# Station Design Competition

## East-West Bus Rapid Transit

## Appendix A. Feedback Summary

## 2140

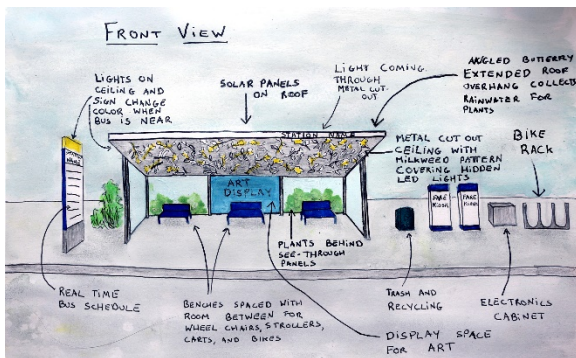
- Very busy – a lot going on.
- Will be hard to keep clean and maintained (broken/ clean glass, chairs, people sleeping, etc.)
- No bicycle features
- Seems very tall
- Obstruct views
- Green roofs are higher maintenance than other roof systems.

- Overall height, clerestory, green roof could challenge budget, but solvable.
- Cantilever roof excessive, but column(s) would not damage concept.
- Constructible if the columns are added to support the green roof ends.

## 4851

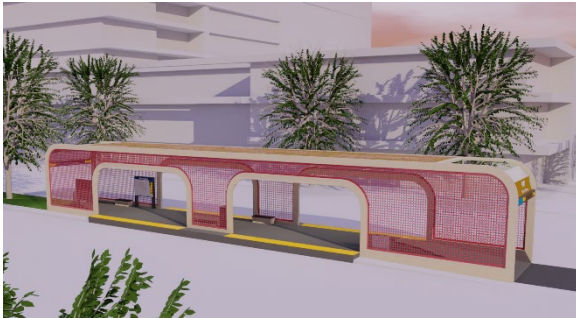
- The use of sandstone
- Plain, not many unique features
- Lacking amenities
- White/ light colors
- Does not appropriately leave room for all doors of the bus

- Need larger size of structural members, but plausible.
- May need gutters, downspouts and connection to storm drain

## 4915

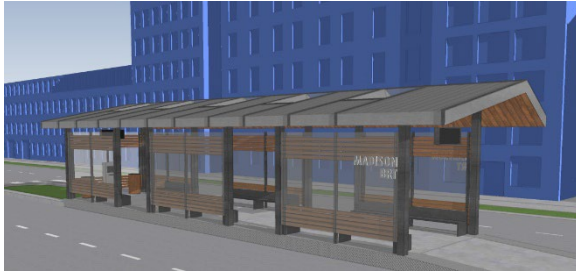
- Too retro, colors are flashy
- Doesn't look like Madison or midwest
- Design would not work well in cold weather.
- Not a great fit for historic context

- Needs additional vertical structure along length & interconnecting outside arch to inside arch
- Needs internal gutters & downspouts tied to storm drains
- Mesh material needs to be durable and sustainable

## 6143

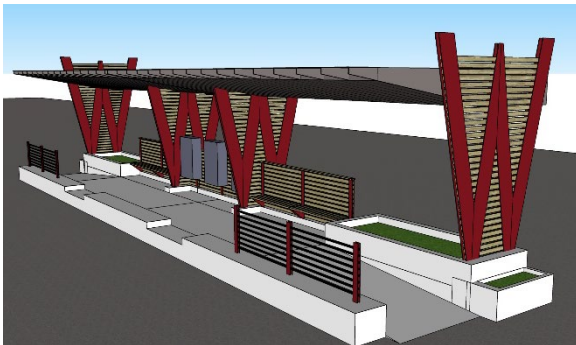
- Too open
- Trees are high maintenance/ impractical
- Circle seating – design and limits accessibility
- Wide/ massive
- Looks like a park or zoo shelter

- Structure not defined, but simple form allows easy introduction
- Not sure what tree elements are
- Probably needs more structural columns
- Needs gutters, downspouts & storm drain connection

## 7014

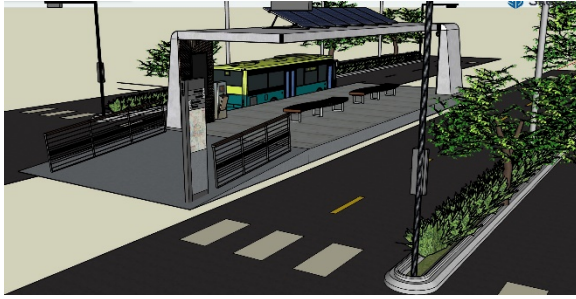
- Design is cliché
- Doesn't fit UW branding
- Not a great fit for historic context
- Not enough seating
- Little protection from weather
- Not scalable
- Wood finishes are more expensive to maintain

- Needs gutters, downspouts and storm drain connections.

## 8472

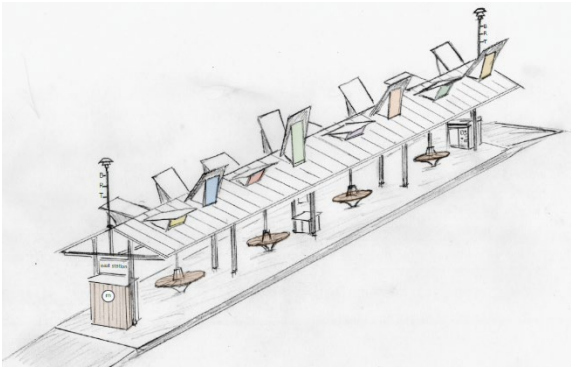
- Too unique
- Lacks any shelter
- Looks like a subway entrance, not BRT
- Dangerous - encourages people to climb up the roof
- Low ceiling clearance on one end
- Wood finish may have a higher maintenance cost than other finishes.

- Relationship of glulam to vertical support in 'w\_Raingarden' picture confusing - meant to shed water from concave shape to sidewalk?
- Depending on highway transport regulations, could be prefab off-site and transported.
- Patron level screenings would need to be sustainable and durable.
- Need downspouts and connections to storm drain.
